## ADDENDUM #9

**Western Slope Food Bank of the Rockies**  
698 Long Acre Drive

**Bid Package #4 – Above Ground**

Architect's Project No. 2108

**HOOD DETAIL**

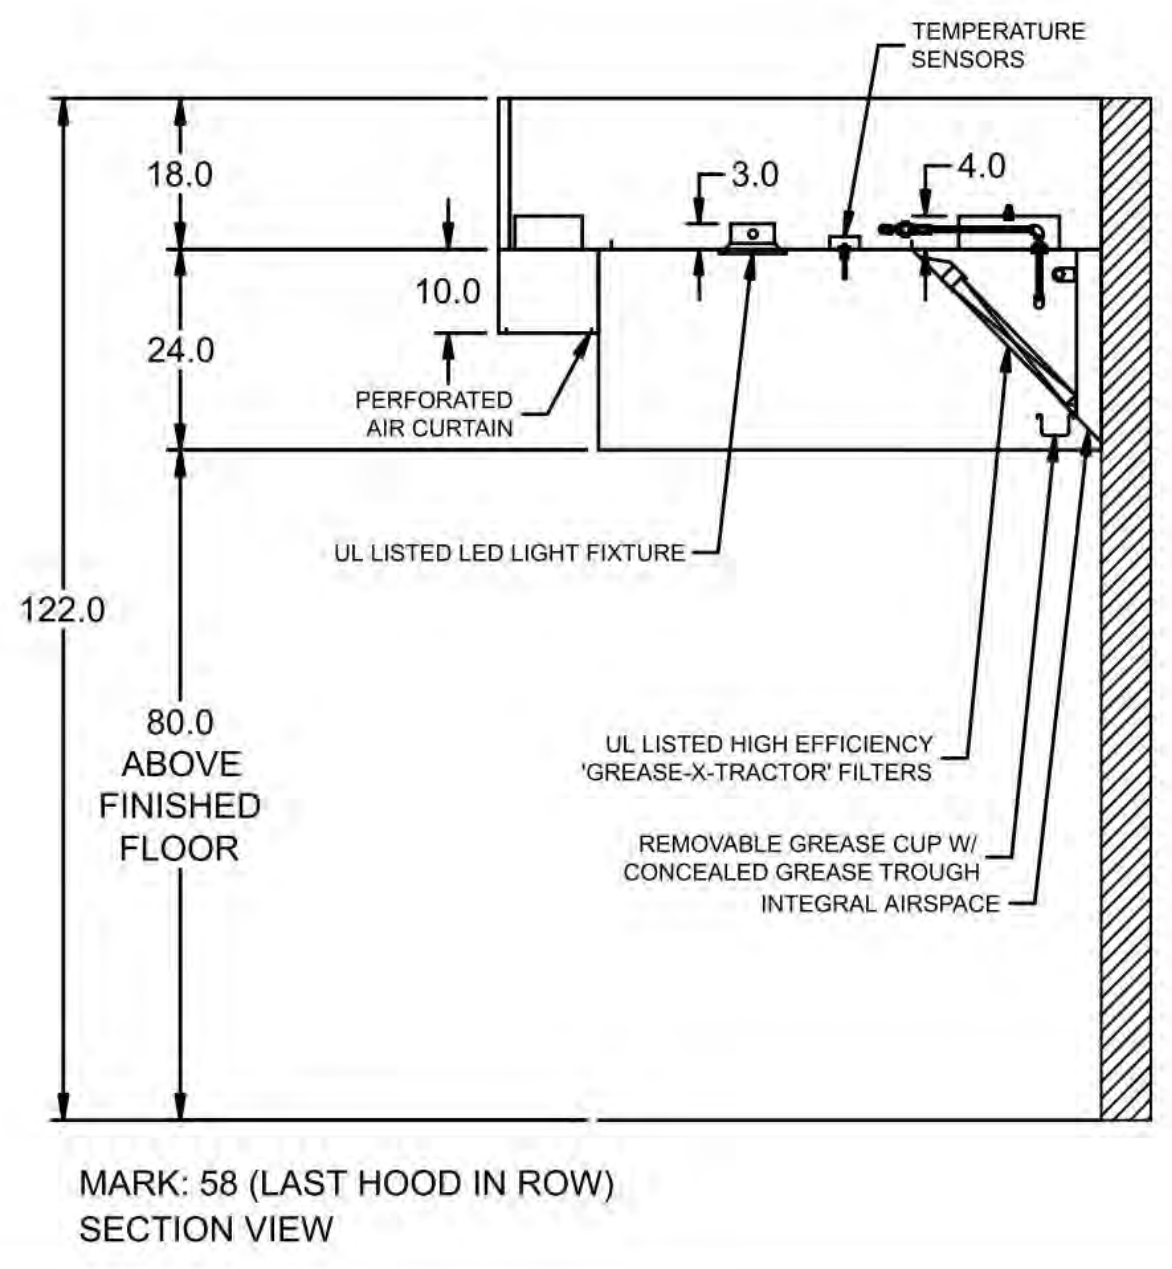
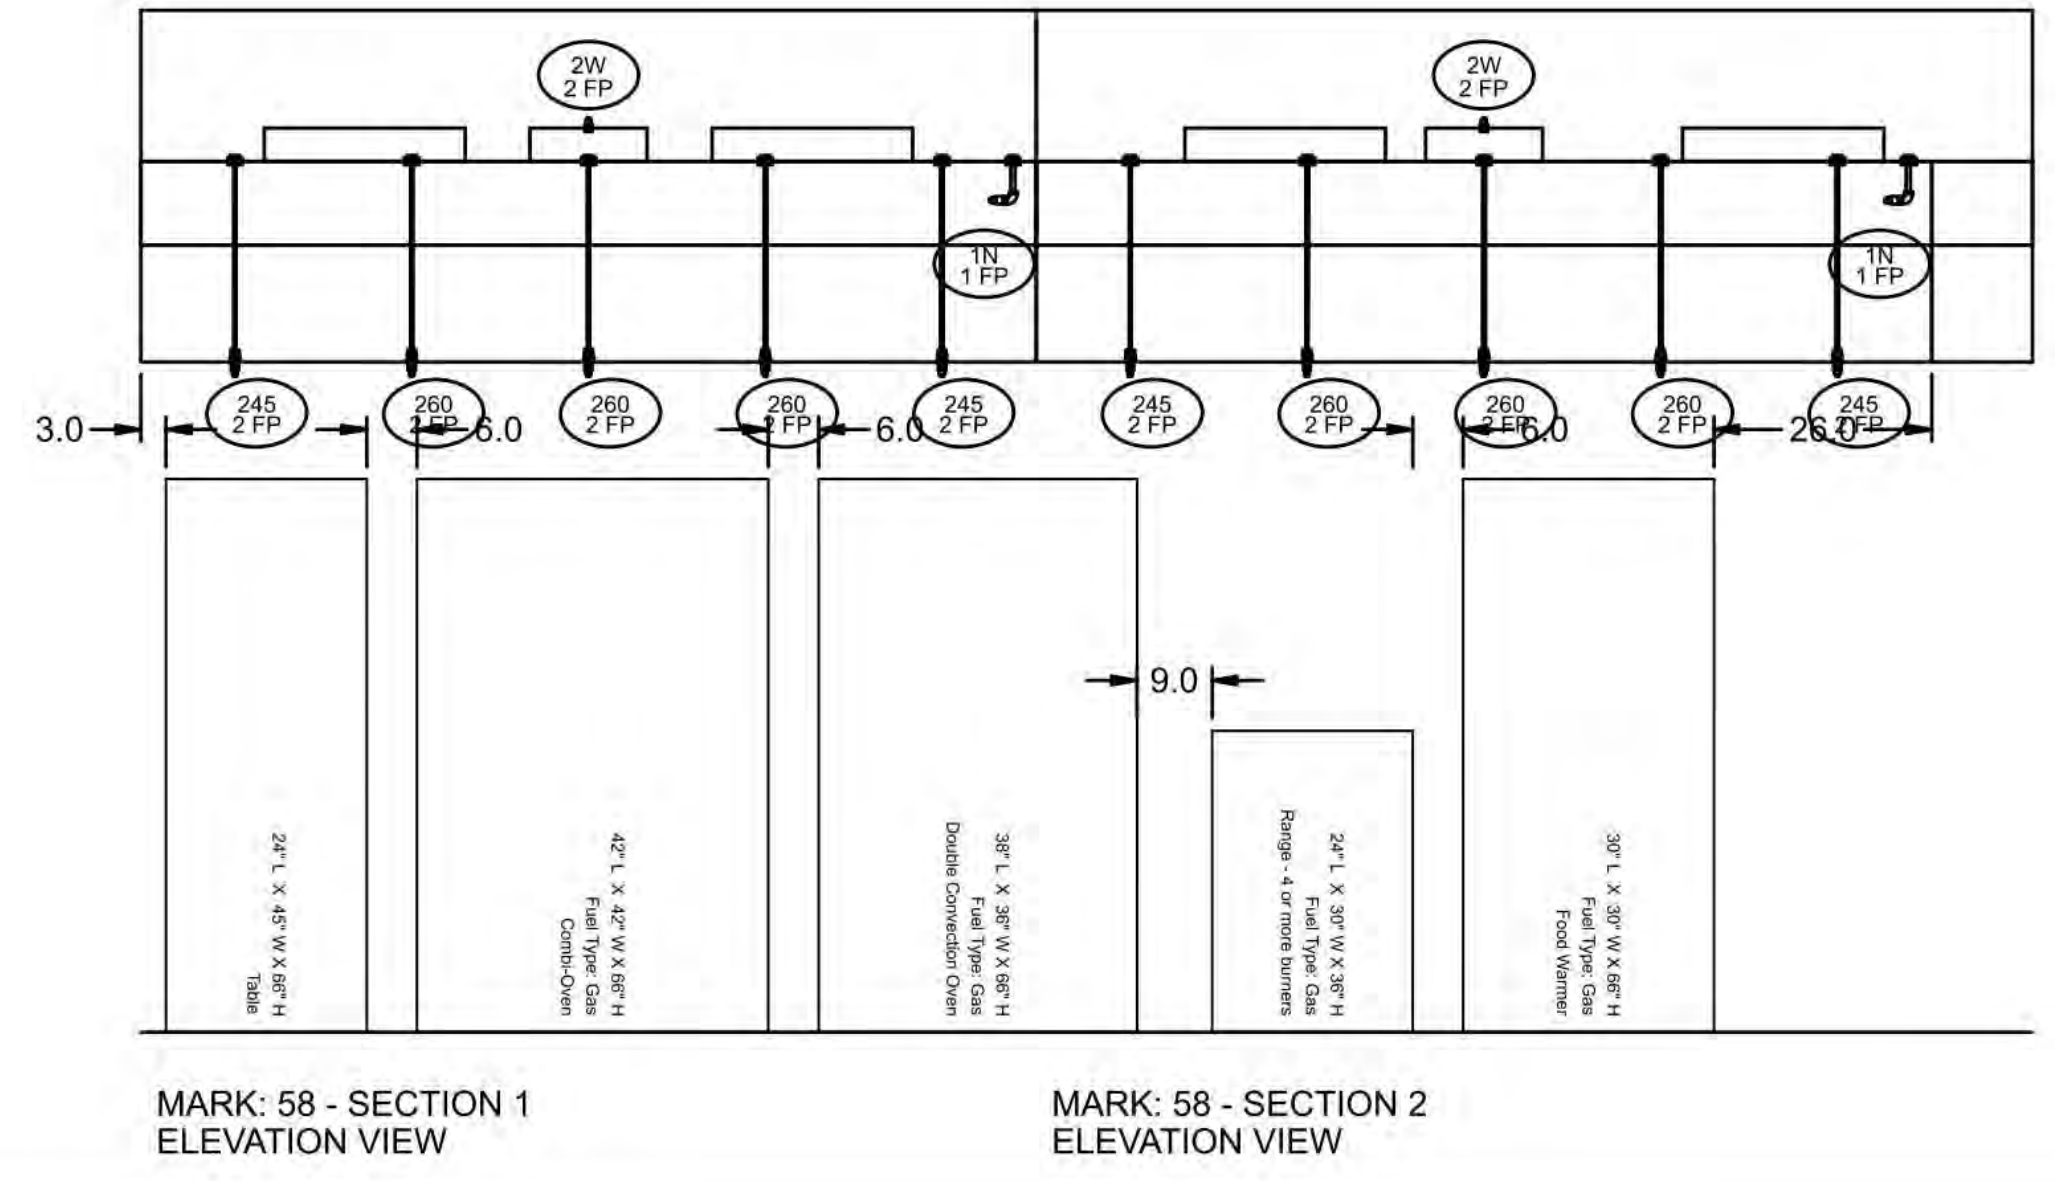
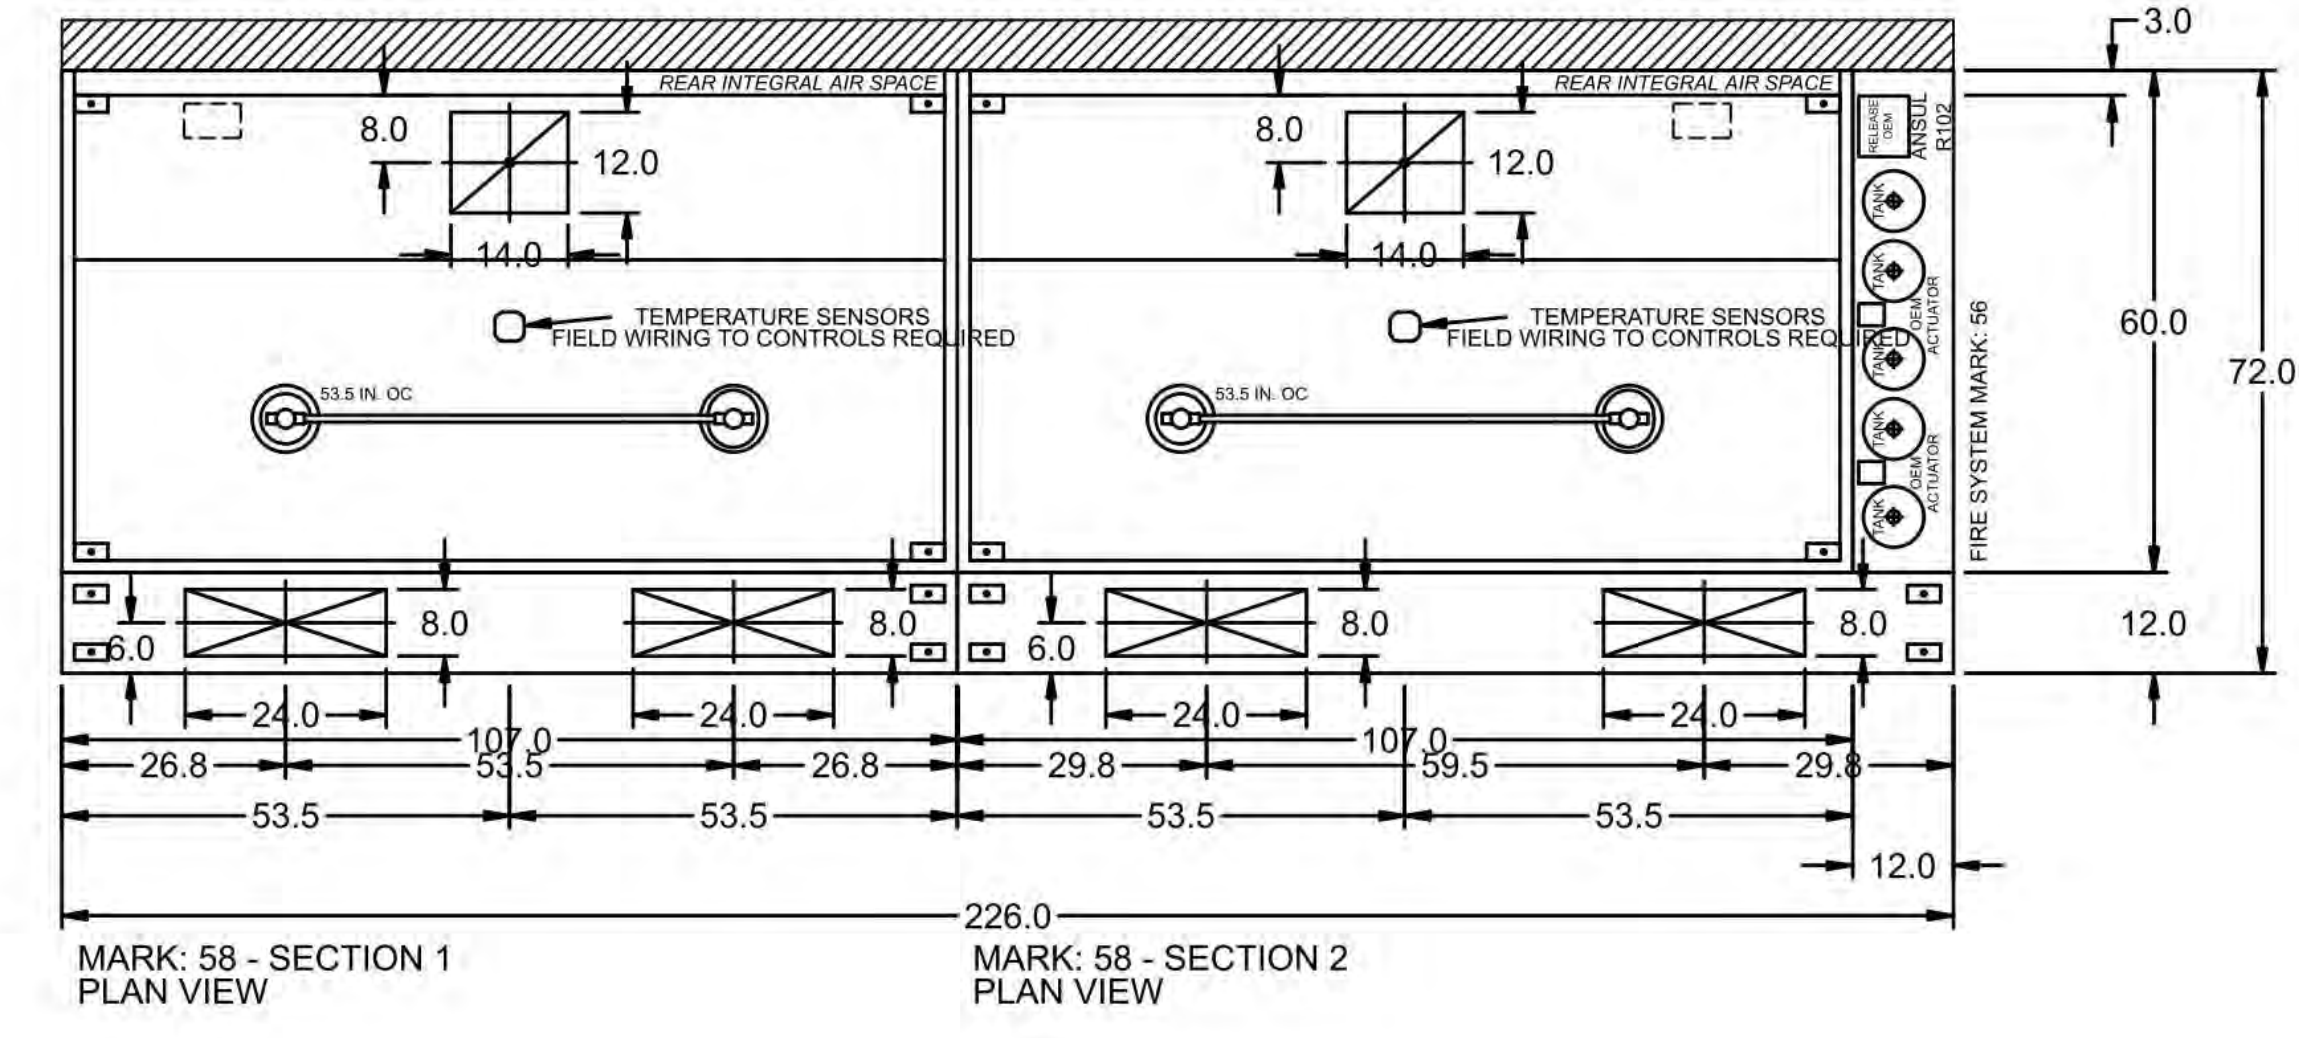
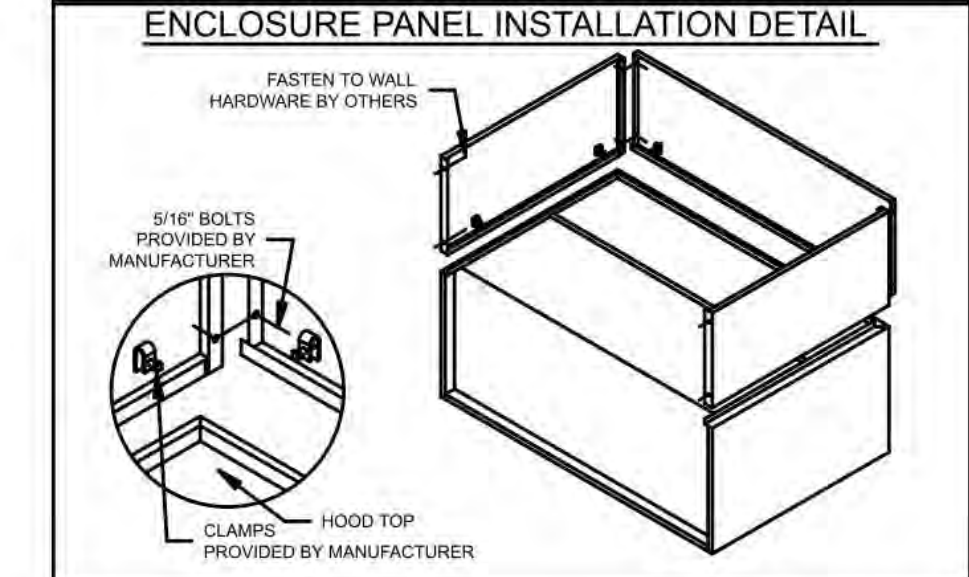
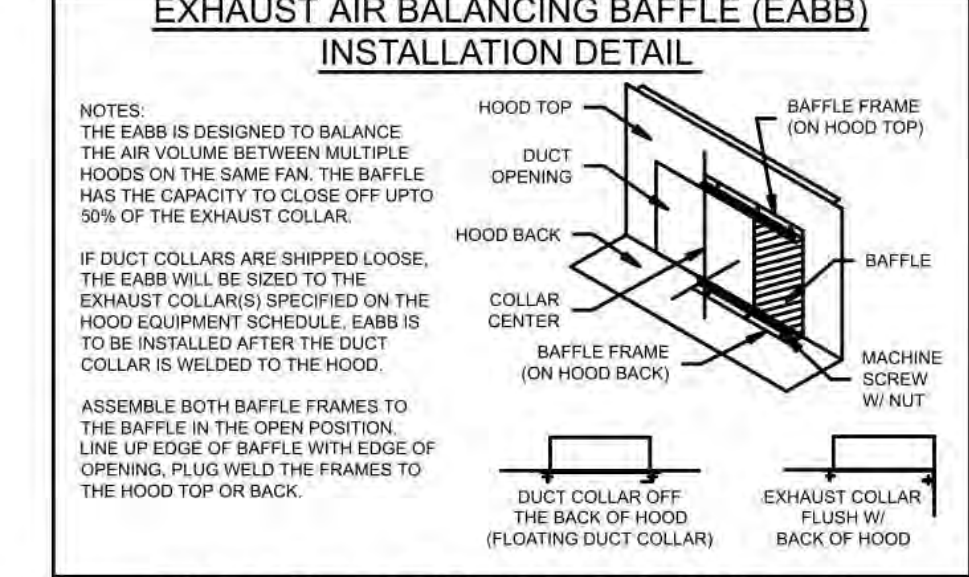
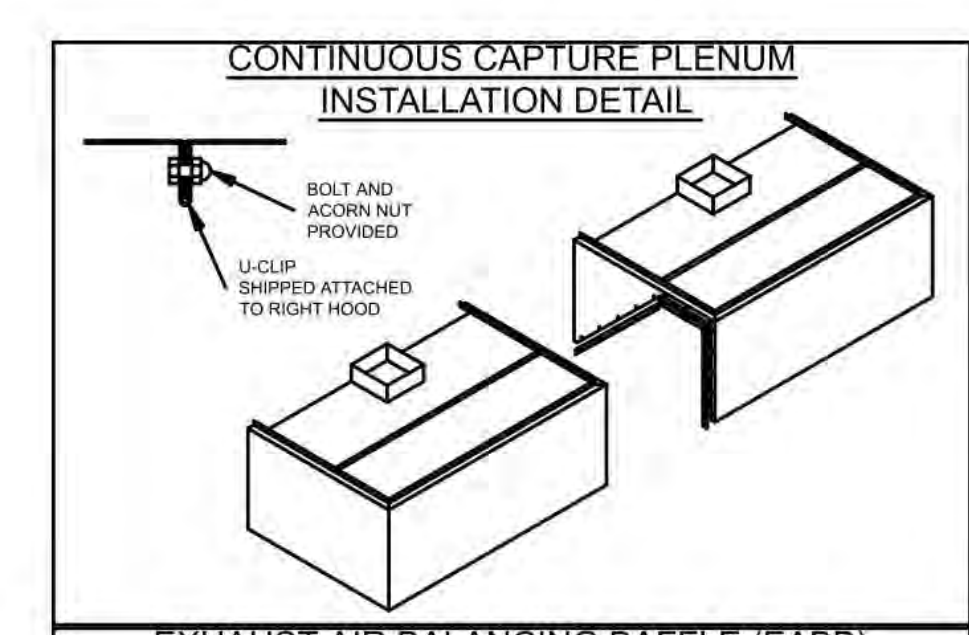
ADD #9  
 THE KITCHEN HOOD ASSEMBLY, FIRE SUPPRESSION SYSTEM, CONTROLS AND RELATED ACCESSORIES AS SHOWN OR SPECIFIED OR REQUIRED FOR COMPLETE AND FUNCTIONAL SYSTEM SHALL BE PROVIDED (FURNISHED AND INSTALLED) UNDER THIS CONTRACT.
